URBAN DESIGN COMMISSION APPLICATION CITY OF MADISON

1. **Project Address:** 510 University Avenue

Project Title (if any): Hub at Madison II

The Hub at Madison II -UDC RE-SUBMITTAL

Drawing Title: NORTH WEST ELEVATION

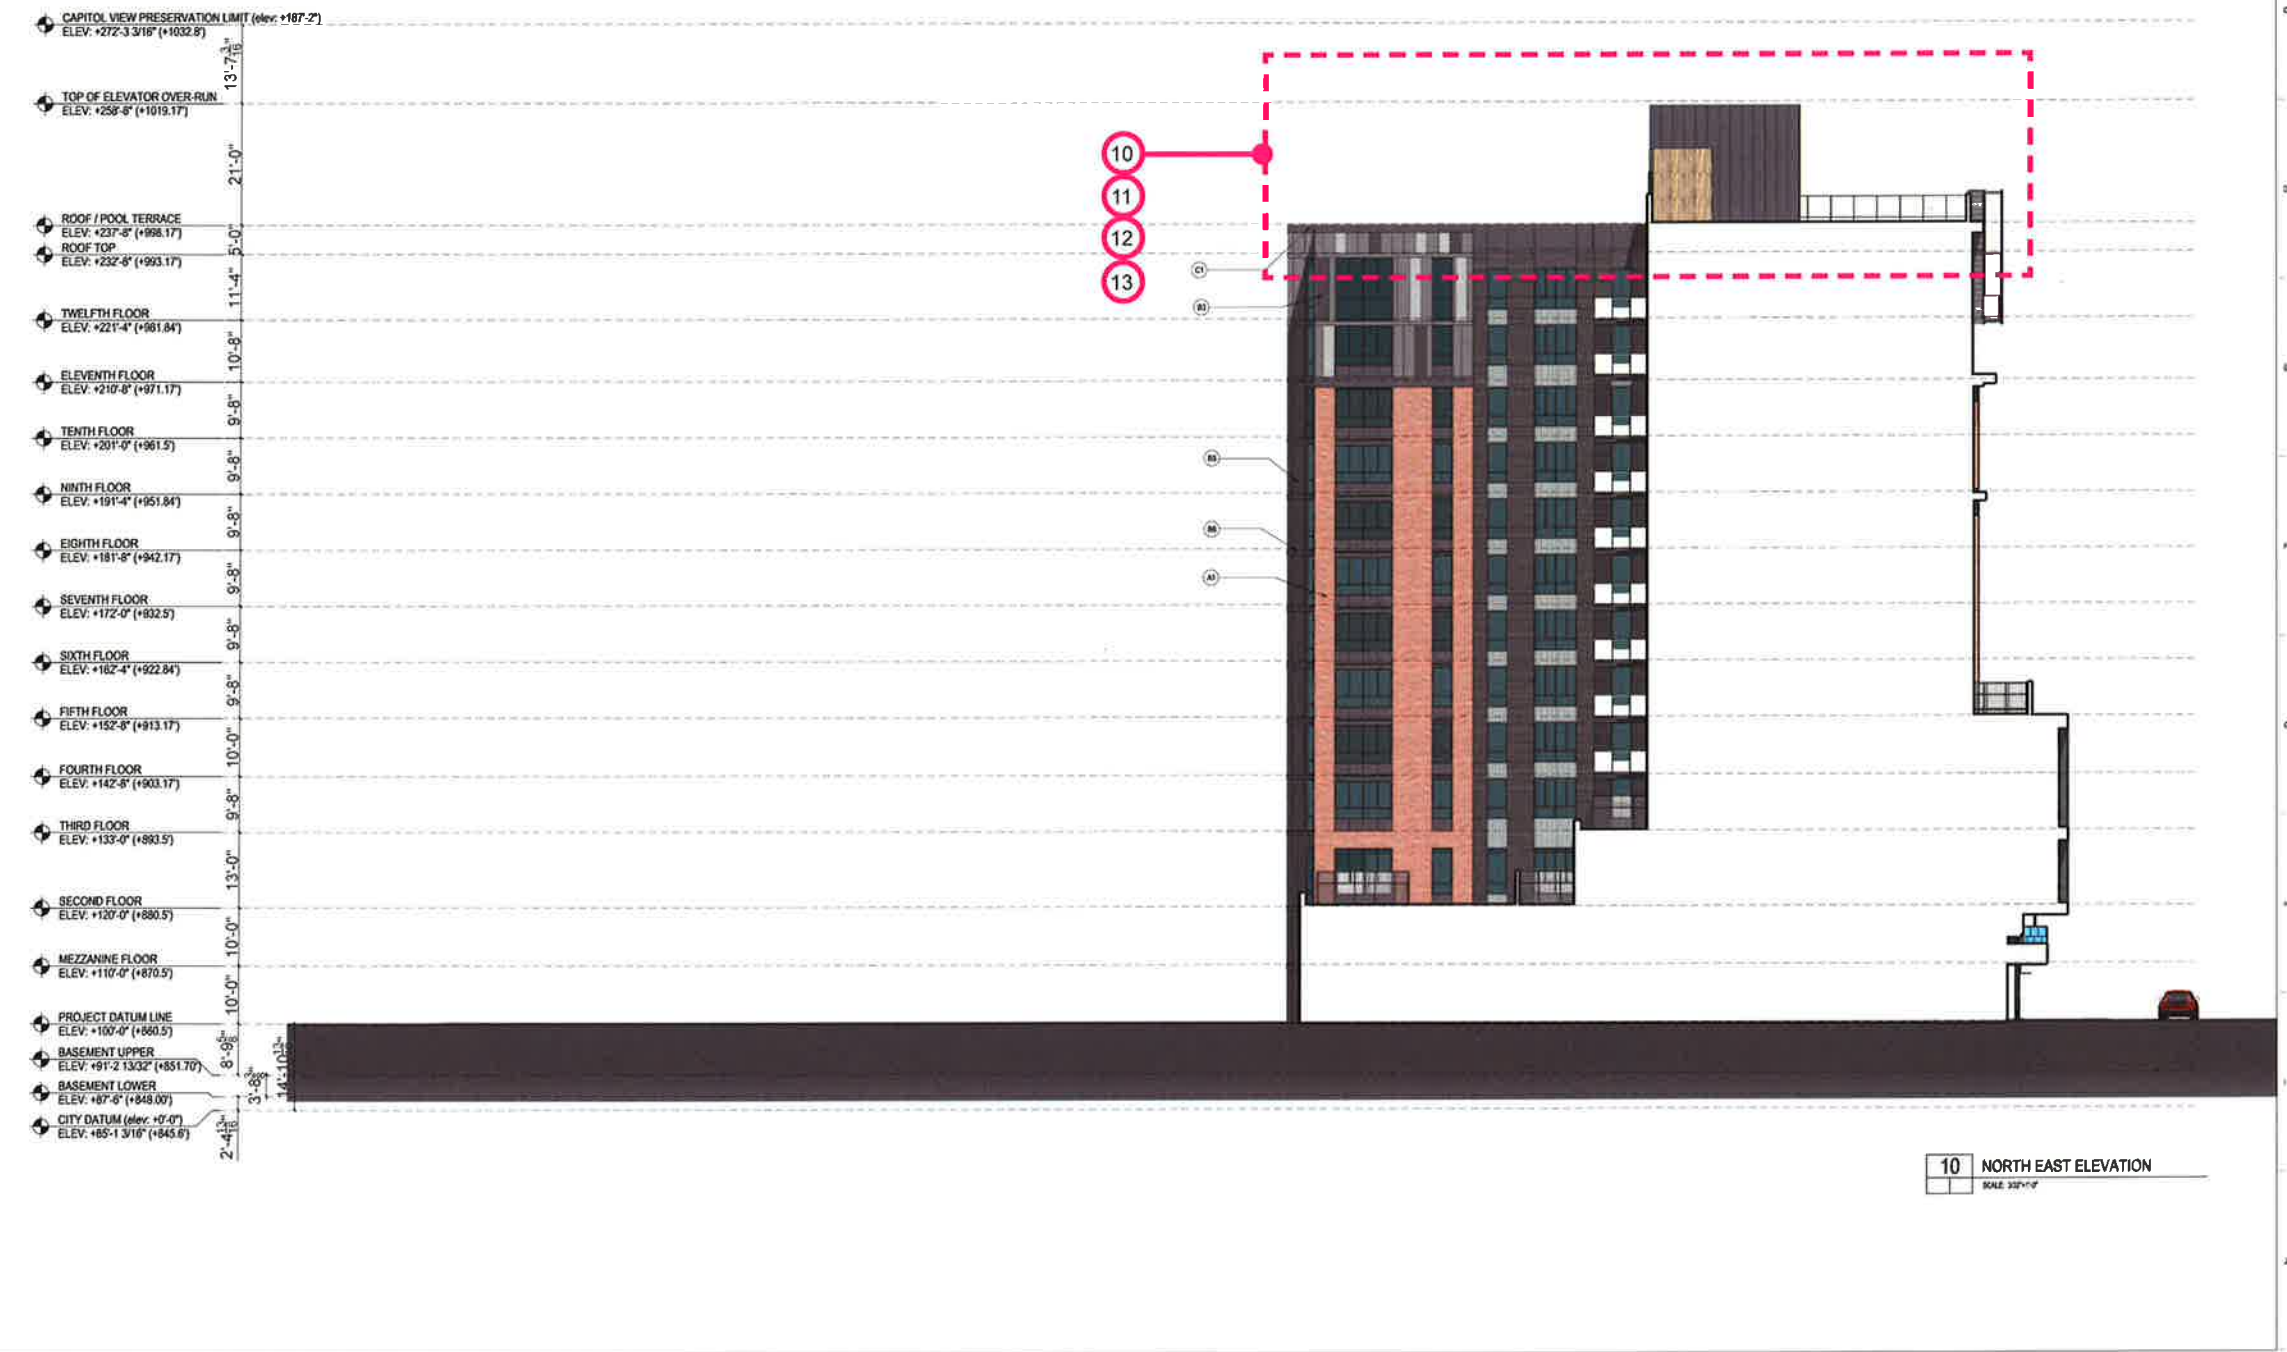
1. Brick knee wall added at University Ave. / Gorham St. storefront.
2. Residential and leasing lobby entry and canopies removed. Lobbies rationalized into one connected space eliminating need for 3 entries. Canopy over entry redesigned to match cladding concept.

3. Storefront subdivisions simplified. Staggered pattern to match metal panel pattern.
4. Corner of University and alleyway revised to reflect change at fire rated vision triangle sightlines.
